OET Inquiry System Reply to OET Response, Inquiry Tracking Number 715914 - Windows Internet Explorer

Currently Display Inquiry Tracking Number: **715914**

1. Rule part : FCC part 15 Subpart C & part 2 (2.1093)
2. The product is a WiFi 802.11bgn usb dongle which has a rotatable antenna
Antenna can be rotated from 0 to 180 degree in one way only.
Equipment Class: DTS - Digital Transmission System
3. test configuration : 802.11bgn product

SAR evaluate position FCC Response

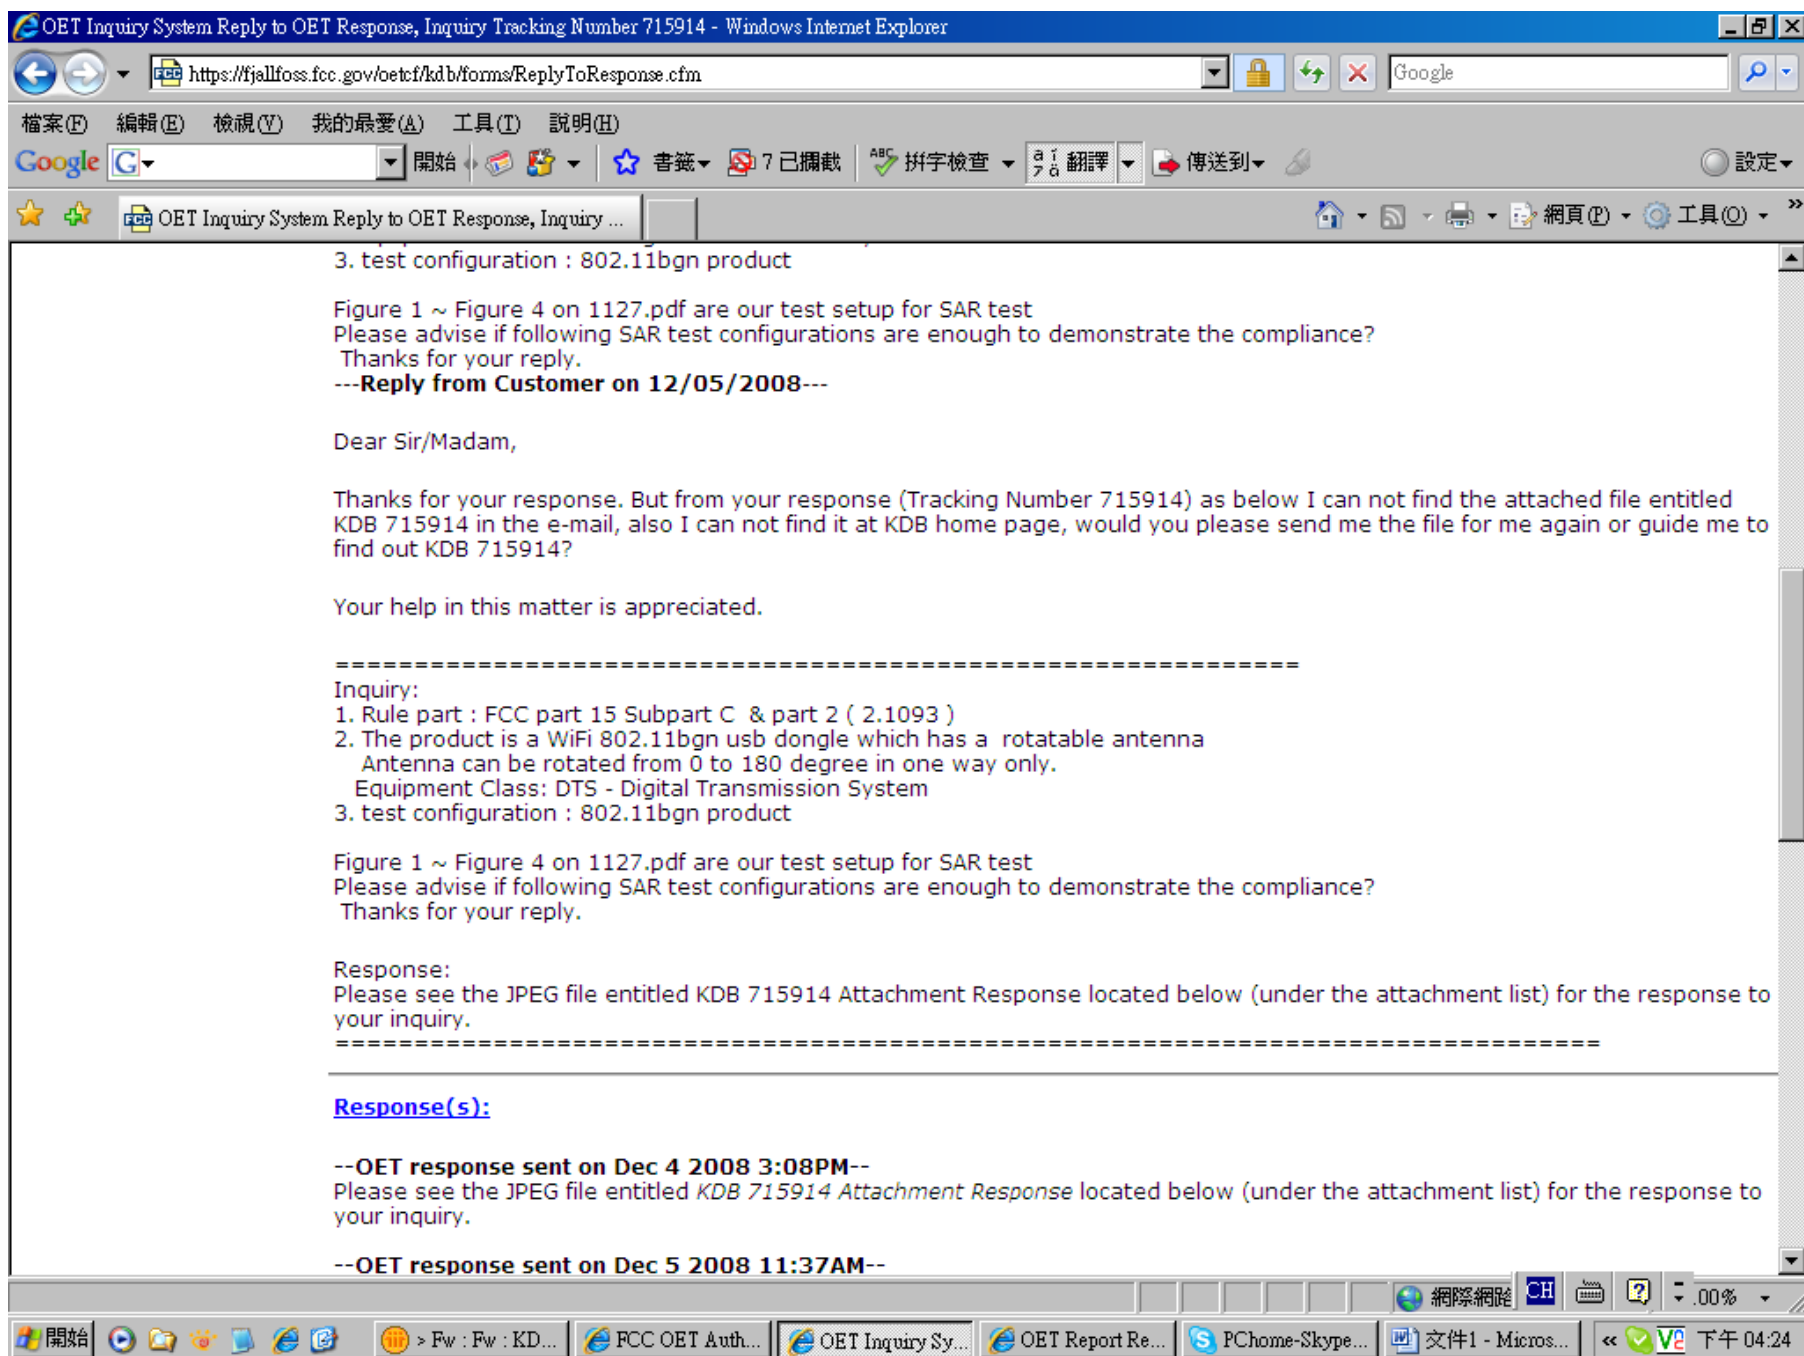
Figure 1 ~ Figure 4 on 1127.pdf are our test setup for SAR test
Please advise if following SAR test configurations are enough to demonstrate the compliance?

Figure 1. Front of EUT
Evaluate antenna 0° and 180° Both positions
Use Laptop for both positions

Figure 2. Bottom of EUT
Evaluate antenna 0° & 180° Both positions- no step
Can use 12 inch or less USB cable

Figure 3. Left of EUT
Evaluate antenna 0° 90° 180° 3 positions to test
Either Figure 3 or Figure 4 must use a laptop for tests

Figure 4. Right of EUT
Evaluate antenna 0° 90° 180° 3 positions to test
